ADDENDUM

ADDENDUM NO.: 03
PROJECT NAME: Design-Build Services for Joint Public Safety Training Campus Phase 01A – Outlot Restaurant Area
CONTRACT NO.: PS3056
DATE OF ISSUE: August 6, 2021

NOTICE OF CHANGES, MODIFICATIONS, OR CLARIFICATIONS TO CONTRACT DOCUMENTS

JPSTC PHASE 1A
COMED UTILITIES | 21-0804

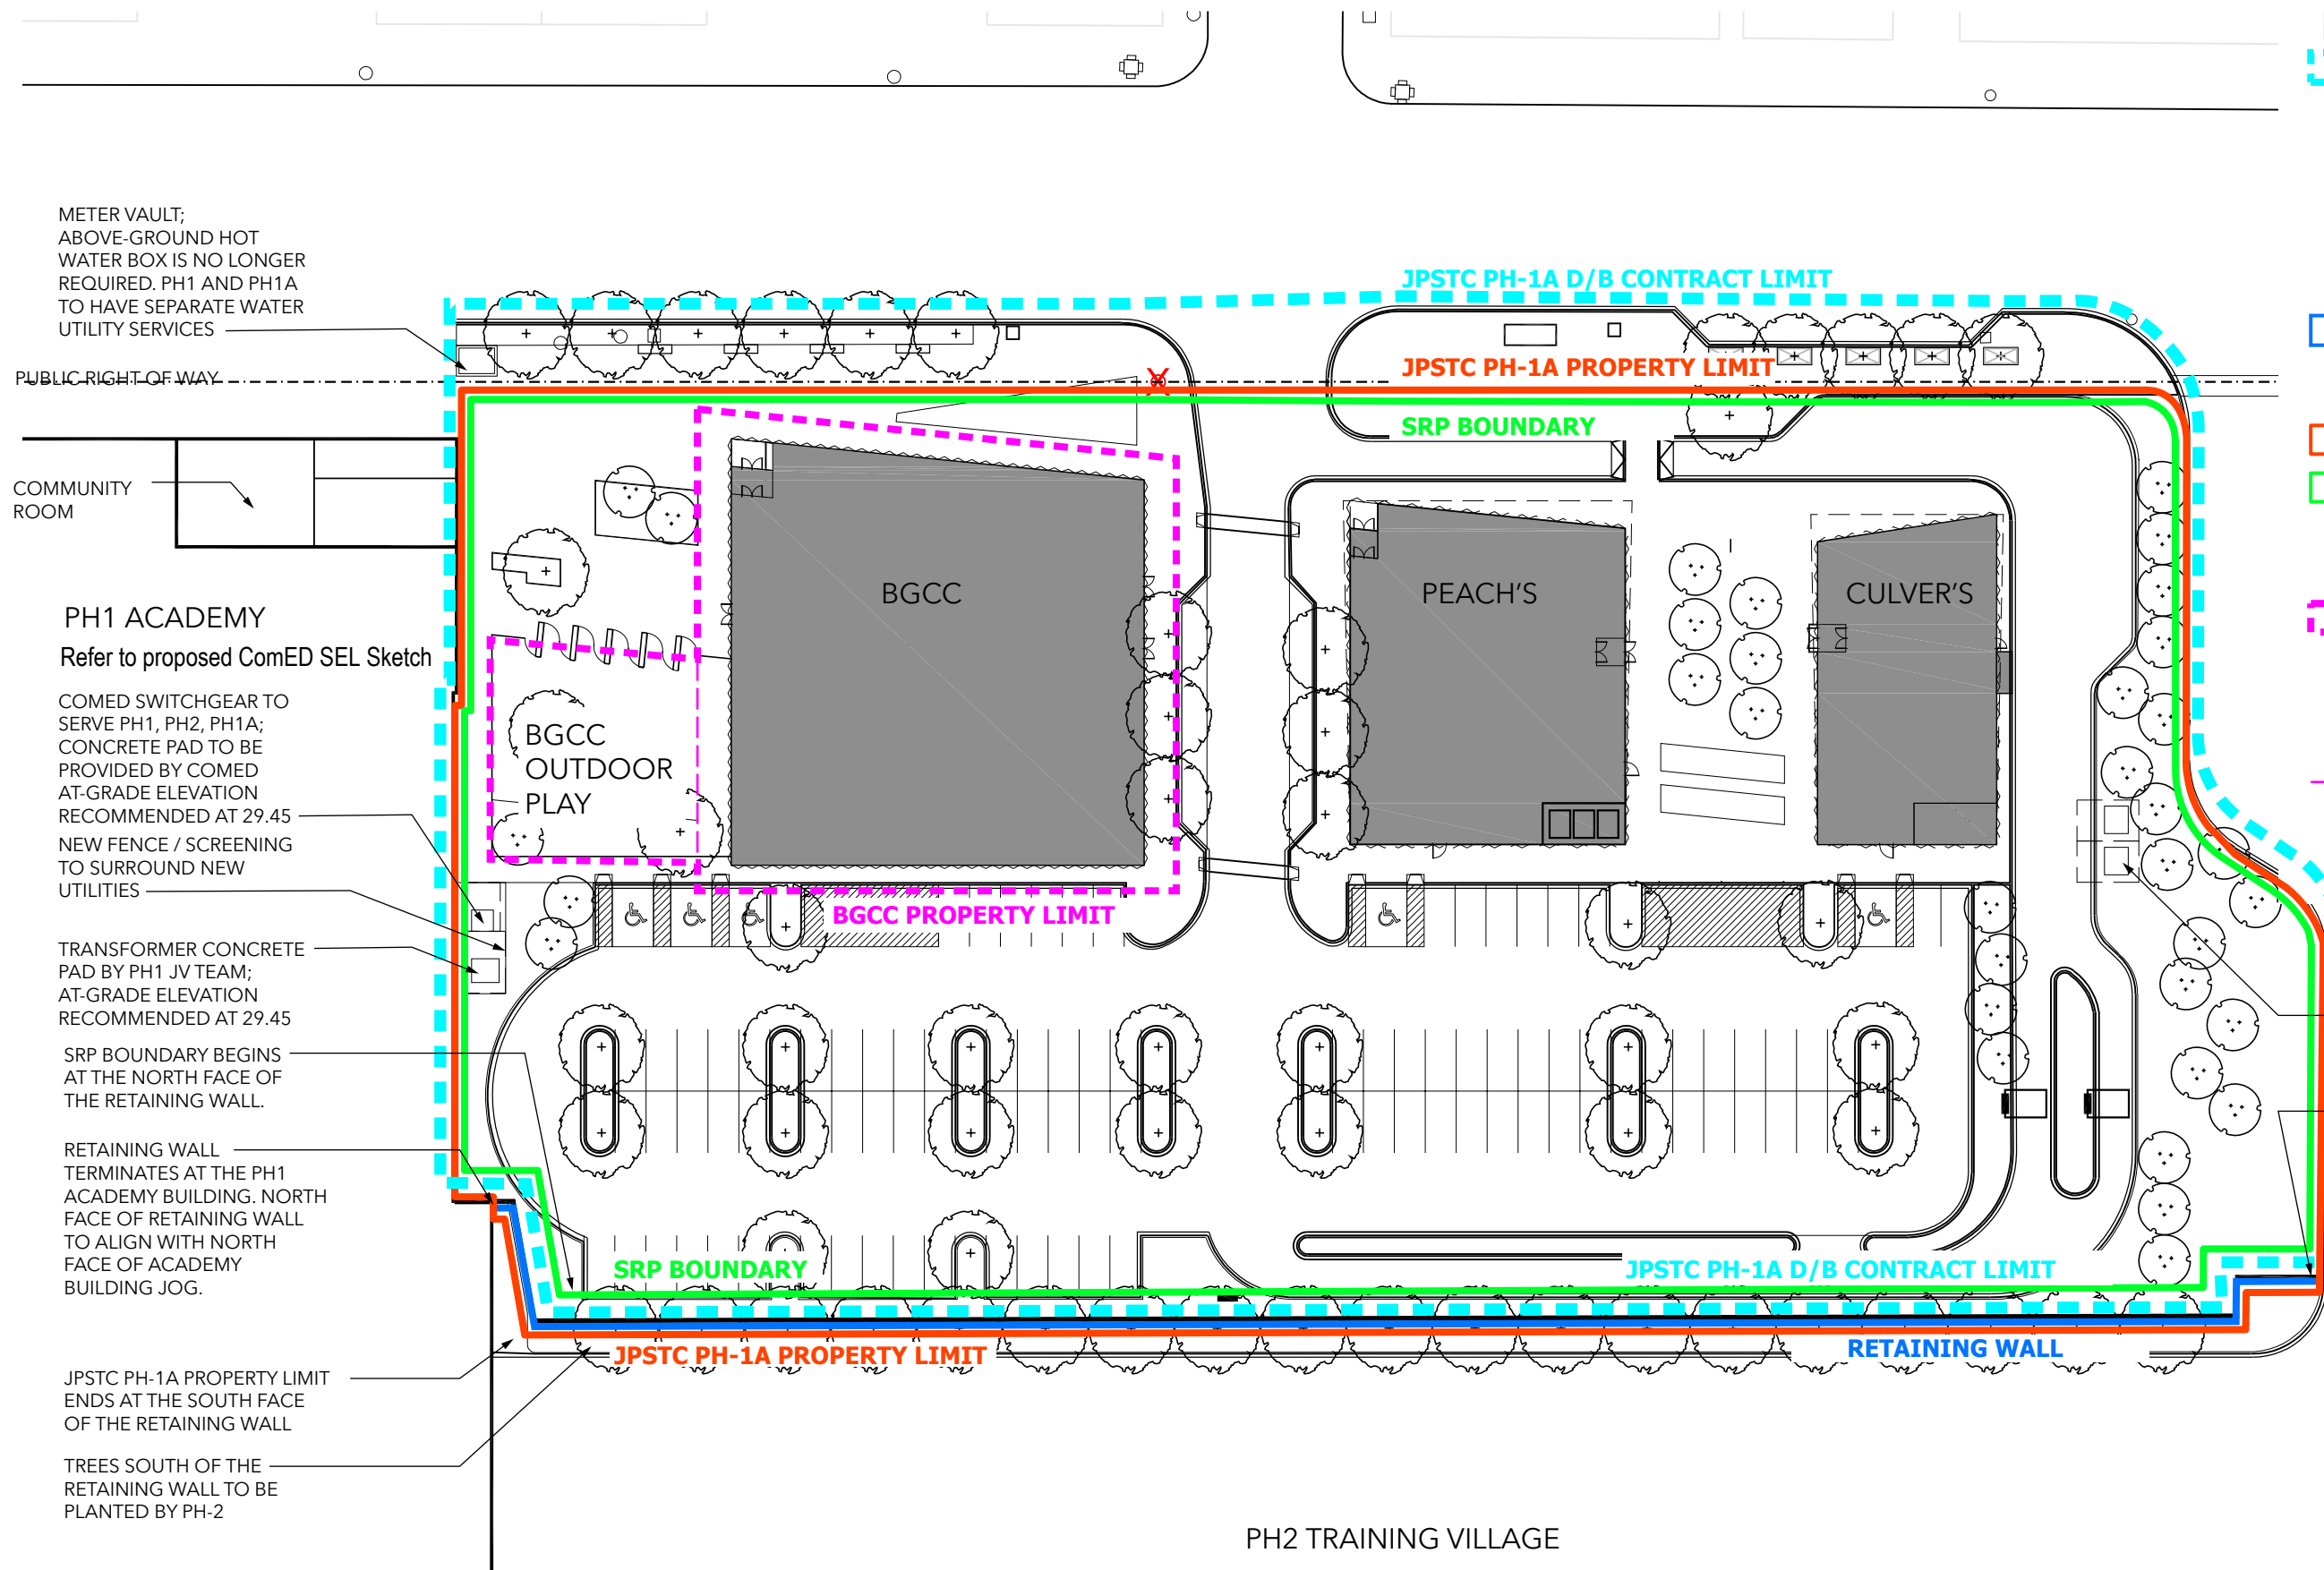
Change 2 DELETE Exhibit J_Feasibility Study drawing labeled DW_LD_LZ_04000-01A_JPSTC_SitePlan_20210616 and **REPLACE WITH** DW_LD_LZ_04000-01A_JPSTC_SitePlanR1_20210804.

THE PH-1A D/B TEAM SCOPE EXCLUDES THE BOYS AND GIRLS CLUB BUILDING AND THE BOYS AND GIRLS CLUB OUTDOOR PLAY SPACE. PH-1 WILL HAVE SOME UNDERGROUND WORK JUST EAST OF THE ACADEMY BUILDING FOR UTILITIES.

PH-1 TO PROVIDE A ROUGH GRADED AND CLEARED SITE FOR THE PH-1A D/B TEAM TO BEGIN WORK WITHIN.

RETAINING WALL WILL BE CONSTRUCTED BY PH-1.

ALL IMPORTED AND EXPORTED SOIL WITHIN THE SRP BOUNDARY MUST FOLLOW SRP GUIDELINES FOR DOCUMENTATION, WITH AIS TO CONFIRM.

ALL SITEWORK AND BUILDING SCOPE WITHIN THE BGCC PROPERTY LIMIT IS UNDER BGCC'S RESPONSIBILITY, WITH THE EXCEPTION OF THE BGCC OUTDOOR PLAY AREA.

ALL GRADING AND CONCRETE PAVING WITHIN THE BGCC OUTDOOR PLAY AREA WILL BE BY THE DB TEAM. ALL ADDITIONAL WORK IS UNDER BGCC'S RESPONSIBILITY, INCLUDING FENCING, FURNISHING, LANDSCAPING.

RECOMMENDED TRANSFORMER LOCATION FOR PH-1A RESTAURANTS WITH NEW FENCE/ SCREENING SURROUND

RETAINING WALL TERMINATES AT PH2 SECURITY FENCE, ALIGNED CENTER TO CENTER.

METER VAULT; ABOVE-GROUND HOT WATER BOX IS NO LONGER REQUIRED. PH1 AND PH1A TO HAVE SEPARATE WATER UTILITY SERVICES

COMED SWITCHGEAR TO SERVE PH1, PH2, PH1A; CONCRETE PAD TO BE PROVIDED BY COMED AT-GRADE ELEVATION RECOMMENDED AT 29.45
NEW FENCE / SCREENING TO SURROUND NEW UTILITIES

TRANSFORMER CONCRETE PAD BY PH1 JV TEAM; AT-GRADE ELEVATION RECOMMENDED AT 29.45

SRP BOUNDARY BEGINS AT THE NORTH FACE OF THE RETAINING WALL.

RETAINING WALL TERMINATES AT THE PH1 ACADEMY BUILDING. NORTH FACE OF RETAINING WALL TO ALIGN WITH NORTH FACE OF ACADEMY BUILDING JOG.

JPSTC PH-1A PROPERTY LIMIT ENDS AT THE SOUTH FACE OF THE RETAINING WALL

TREES SOUTH OF THE RETAINING WALL TO BE PLANTED BY PH-2
